Otago Regional Council
Private Bag 1954
Dunedin

Proposed OceanaGold Coronation North Project, potential effects on ground water at the Kinney Property

Figure 1 Location of Kinney property relative to proposed CNP (scale -one blue square is 1 km)

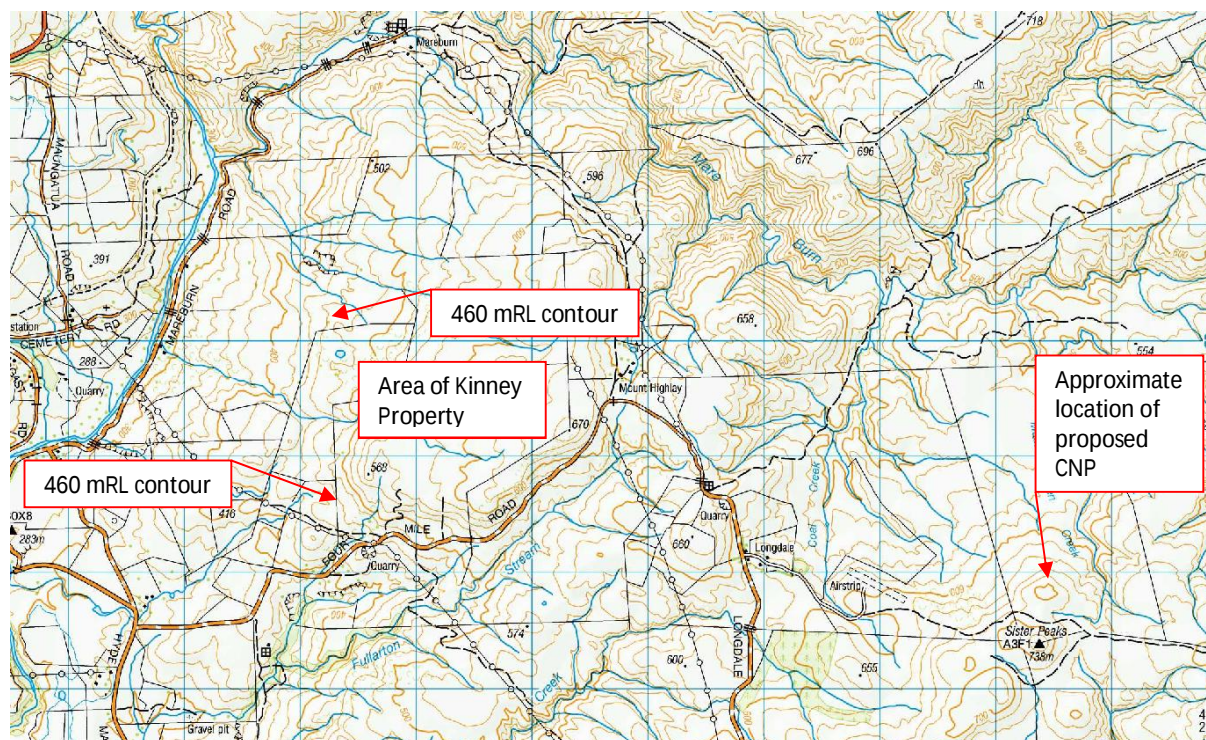
The Kinney property is located north-west of Four Mile Road and east to south-east of Mareburn Road; the distance is approximately 4 km from the proposed CNP pit to the closest point on the farm. Figure 1 following illustrates the locations. A Golder drawing shows the approximate distance from the proposed CNP to the south edge of the Kinney property is from 5.5 km at the 460 mRL contour. The property of interest mostly faces north-west and rises from an approximate elevation of 300 mRL near the Taieri River to a height of about 670 mRL adjacent to the top of the property.

Approximately a little under half the Kinney property is below the 460 mRL contour i.e. lower than the depth of the pit base at its deepest point.

Ground water contours provided by Golder indicate ground water flow from the proposed CNP location is northwards towards the Mare Burn. Coal Creek, a Mare Burn tributary is located down slope of the proposed CNP between the proposed CNP and the Kinney property. Figure 1 shows that Coal Creek is generally below 500 mRL directly between the proposed CNP pit and the Kinney property.

- 2 A significant portion of the Kinney property is below 460 m RL, this is lower than the minimum elevation of the pit base at its maximum depth. We understand that OceanaGold do not propose to dewater below the base of the pit. Consequently, it is very unlikely that springs below 460 mRL will be adversely effected by the advised dewatering regime. We understand that most of the springs of interest to Mr and Mrs Kinney are on the lower slopes of their property.

- 3 It is likely that Coal Creek intercepts ground water, including some ground water from the proposed CNP area. It is very unlikely that water incepted by Coal Creek can emerge from springs within the Kinney Property.

- Golder Associates Figure D3 – Coronation North Pit Groundwater Area of Influence (May 2016)

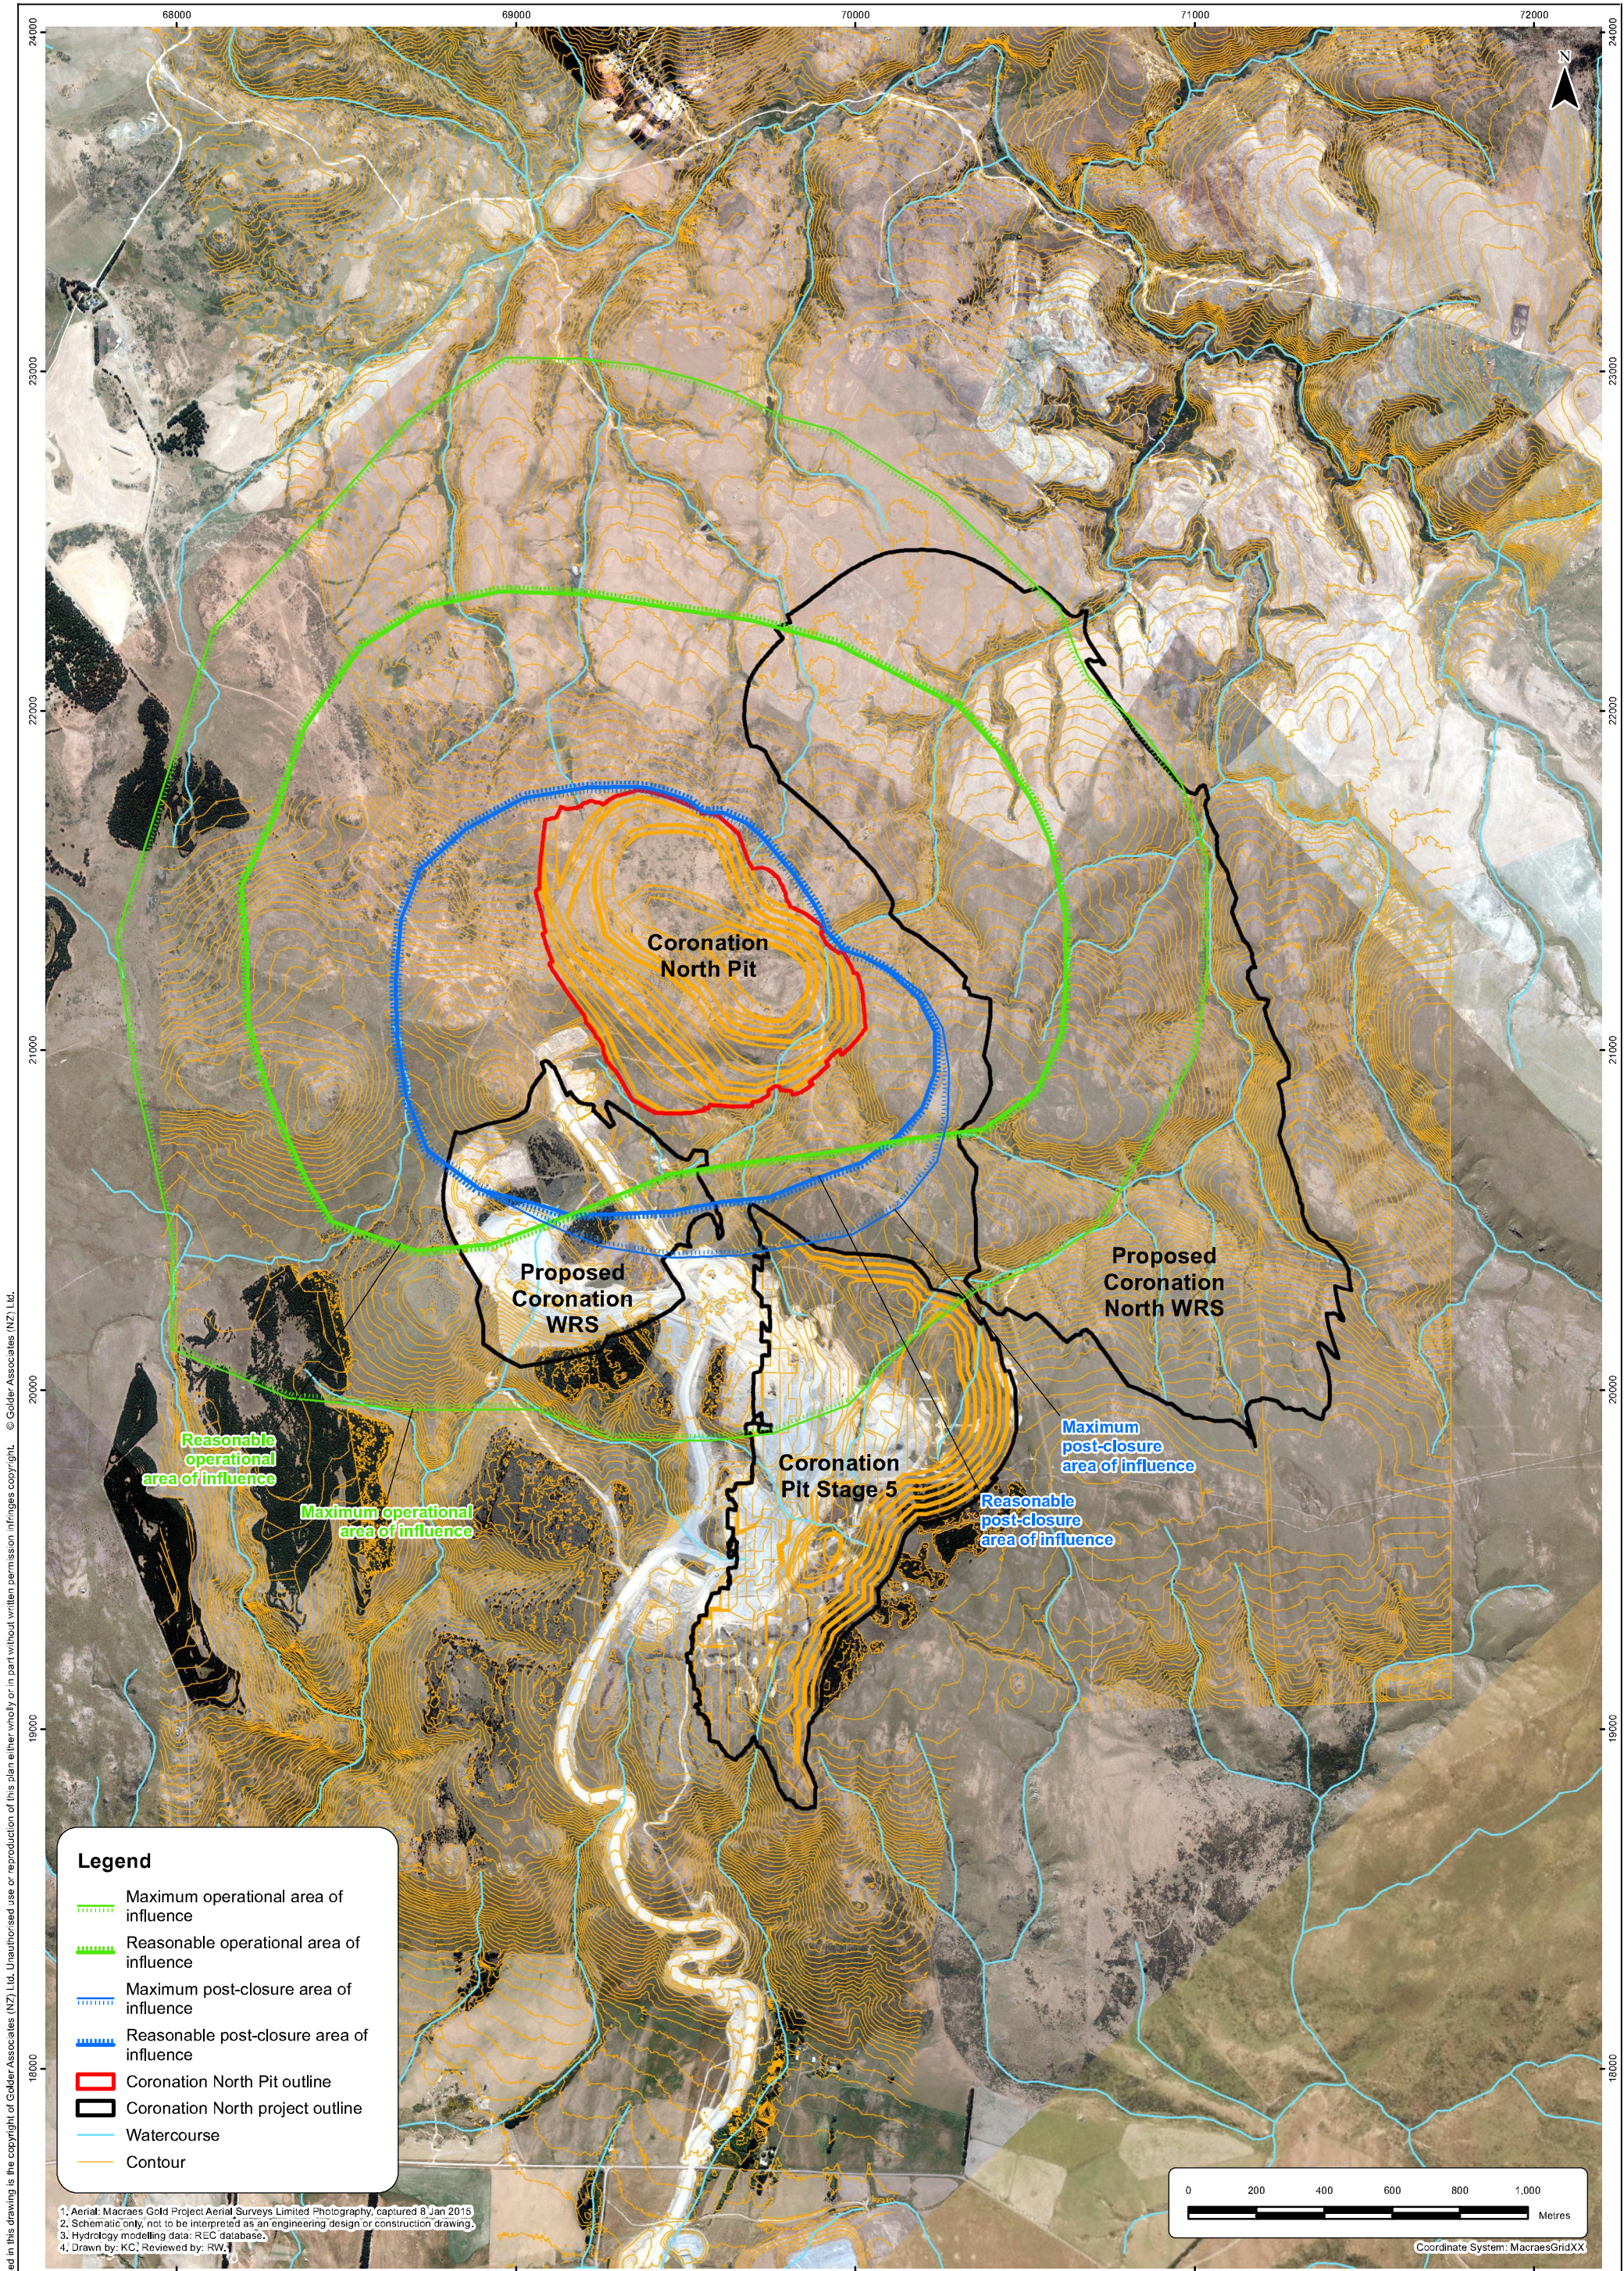
- 1 The Kinney property is significantly beyond the “maximum operational area of (groundwater) influence” provided by the applicant and attached to this letter. The Kinney property is several kilometres from the proposed CNP whereas the advised “maximum operational area of (groundwater) influence” is several hundred metres from the proposed CNP. The Golder

Appendix D is silent insofar as the precision of their analyses are concerned and we have assumed that it is appropriate to use these data to consider the potential effects on ground water at the Kinney property given the relative distance of the property and the zone of influence from the proposed CNP pit.

The Golder report does contain various limitations. On this basis, and given the basis of our comments, we recommend that the Applicant confirms that the potential effect at the Kinney property as a consequence of the proposal is not more than minor.

One or more ground water monitoring bores could be installed outside of the advised “maximum operational area of influence” in order to confirm that the ground water level is unaffected by dewatering operations. If included as a resource consent condition, a suitable level of base line data is recommended prior to dewatering. It may be appropriate to limit dewatering if ground water levels measured in monitoring bores beyond the advised “maximum operational area of influence” respond to dewatering activities associated with the development.
